WESTRIDGE ROAD REHABILITATION PROJECT – SURVEY ANALYSIS –

OCTOBER 30 – NOVEMBER 15, 2020
PUBLIC ENGAGEMENT – OPEN HOUSE

Street Section Option 1

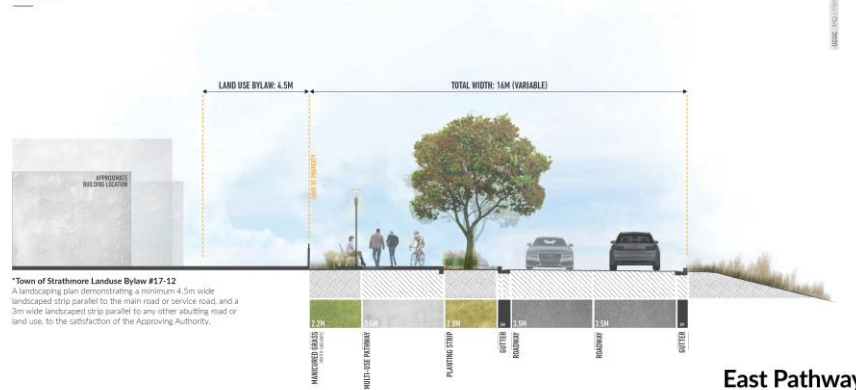
- Provides for the safety of non-motorized traffic (with landscape strip next to roadway)
- Curb appeal - offers practical design for "beautiful highway commercial" setup (hard vs soft surface area)
- No delivery lane - businesses should load/unload deliveries and provide ample parking within their lots.
- Pathway way and connectivity to the east of town needed
- Combine Option 1 (landscape & pathway) and Option 2 (delivery load/unloading lane)
- Design should be implemented both sides of highway

Don't see a need for trucks to stop - should try to prevent this
Install community planter boxes to grow food in place of grass
Provides shade for the users of the walkway
Road too wide reduces the small-town feel, need to add green like the downtown area
Should not design around businesses (may not exist in 15-20 yrs); some businesses need to relocate south of Hwy
For future development of businesses within the town
Option 1 seems the way to go
How will police no parking in the loading lane?

Street Section Option 2

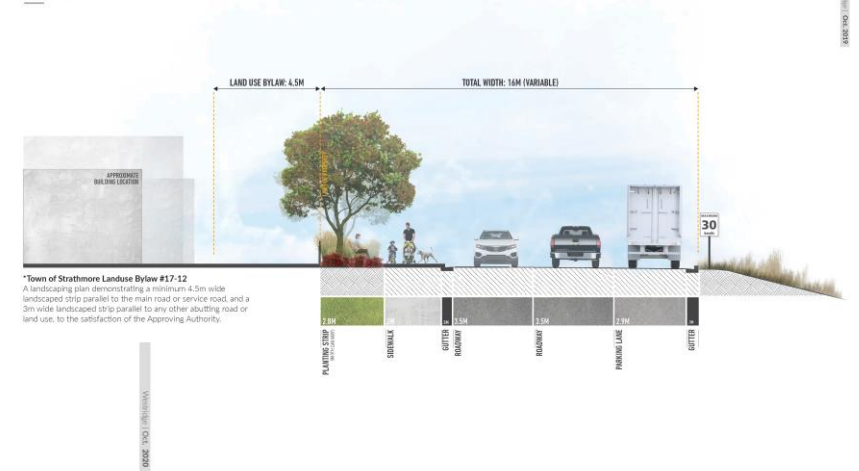
- Safest place for truckers for deliveries and place to stop and shop
- Best option (street appeal), greatest level of usability and functionality for traffic, pedestrians & businesses
- Add landscaping directly adjacent to roadway for safety or use Option 1 landscaping
- Delivery lane should be for parking
- Don't believe there are enough pedestrians to require a path
- Will make town more attractive and encourage travellers stop and check out what we have to offer
- Most cost effective and practical for service road

Divert pedestrians and cyclists to Westmount Road
 We are still a driving community
 Provides shade for the users of the walkway
 Believe more environmentally friendly and easier to maintain for the town
 Should be extended west to Auction Mart
 Like the addition of pathway for connectivity
 What impact will this have on the Hwy# 1/Westmount/Westridge intersection?
 Need same on Ridge Road, pathway and stopping lane
 Glad road getting attention
 2 Negative comments: absolute garbage and keep wasting money on bad designs
